**Flood Control Project Maintenance
Levee Inspections**

Maintenance Issue Types Only, Levee Inspection Report By Mile - Fall 2019

Sacramento Maintenance Yard Willow Slough Bypass

Photo 1 of 3 : UCIP_FA_2019_45286_22464.jpg

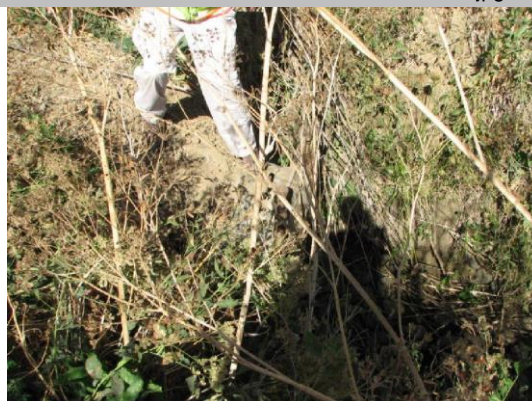
Comment Code					
Inspector Comment					
DS_ID:534 FS_ID:45286 EP_NO: 10327 Repair Type: No Action Needed Crossing Status: Found UCIP Comments: 04/12/2017 WS & LS - good/clear, inspected by JK, RF. (DWR Sacramento Yard - C. Lund) 05/24/2013 Flap gate repaired. (DWR Sacramento Yard - C. Lund) 09/20/2012 Flap gate is not properly closing. (DWR UCIP - P. Amatya) FIELD_STRUCT_DESC: 24-inch corrugated drainage pipe through the levee, 17.5 feet below the crown. Flap gate is located on the waterside (WS) slope. (24-inch pipe [HLM 0.78] authorized under Automatic Board Order (ABO) issued as Permit No. 10327 - Heidrick). [Additional Reference(s): DWR Levee Log, 1990. USACE Sacramento O&M Manual Unit 120, Willow Slough Channel Relocation and Levee Construction, February 1947, Drawing No. 50-4-2281 Sheet 1 (Station 47+00)] FS Date: 5/14/2015 1:36:52 PM

Waterside view- concrete headwall and CM pipe
